FIELD SERVICE BULLETIN

FSB Number: LVCCFSB2005-286
Authors: Darwin Garcia
Date: September 12, 2005
Total No. of Pages: 2
Subject: **V3 Camera Module Insufficient Solder**
Model Affected: **V3**
Level of Repair: 3 & 4

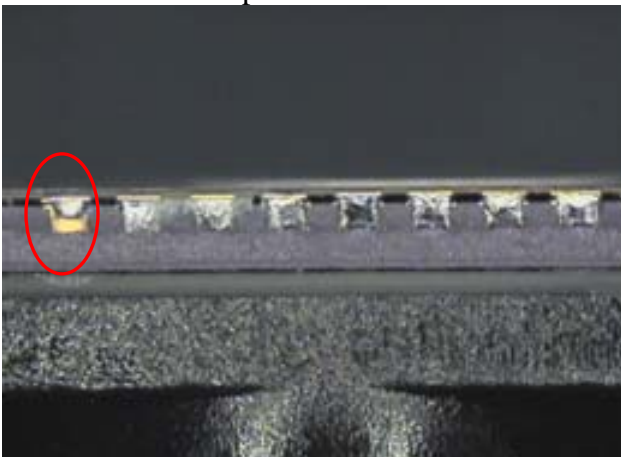
Service has been made aware of a V3 insufficient solder issue on the camera module causing "Camera - Poor Quality and Camera - No Function" complaints.

The root cause was determined to be soldering joint issue on the camera module caused by insufficient solder paste.
